Product Change Notification

Change Notification #: 112985 - 00
Change Title: Intel® Server Chassis H2312XXKRS
PCN 112985-00, Product Design
Update Chassis Architecture
Date of Publication: June 11, 2014

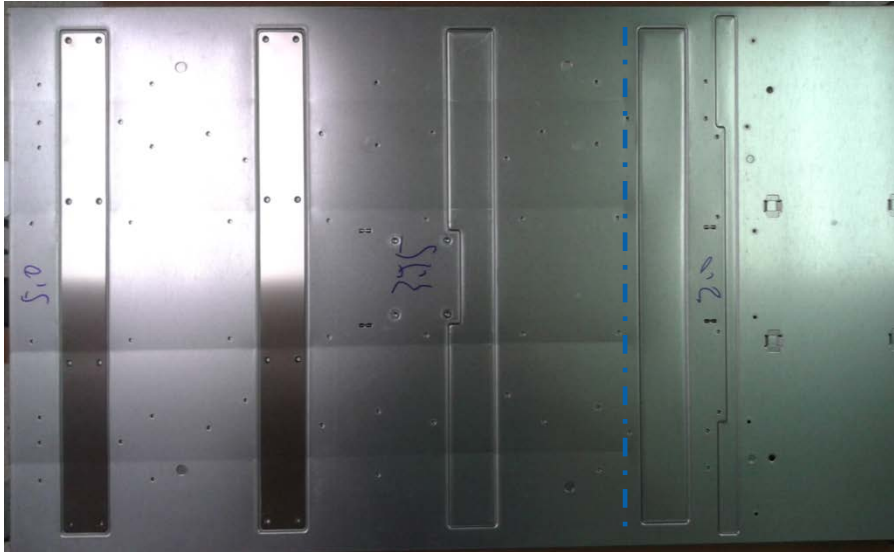
The chassis base architecture has been strengthened with the following updates so that the middle of the chassis will not sag when the system is installed in a rack.

1. Add four emboss areas on the chassis base with two stainless strips to strengthen the chassis base (see the picture below).

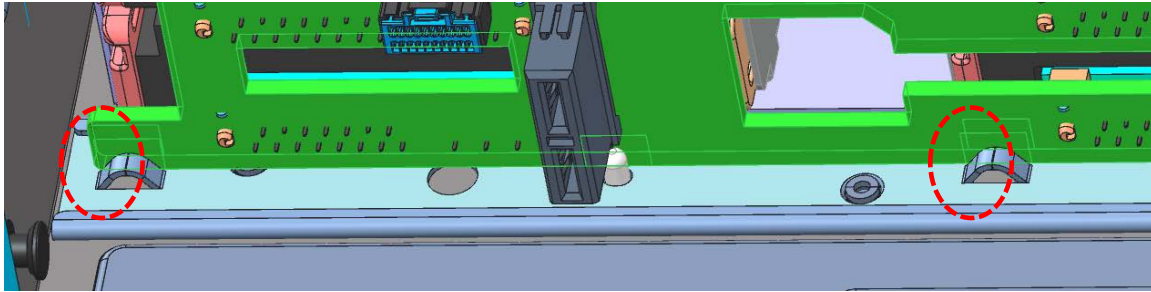
- When installed in the rack, the chassis will be pre-bent along the four crimping lines in the opposite direction of the potential chassis sag. The chassis will show a slight horizontal bow when empty, but will be completely horizontal when all modules and other components are installed in it. The crimping lines end at the blue line as shown below.

- Add five emboss areas on the rear of the top cover to strengthen the chassis to prevent the chassis sag.
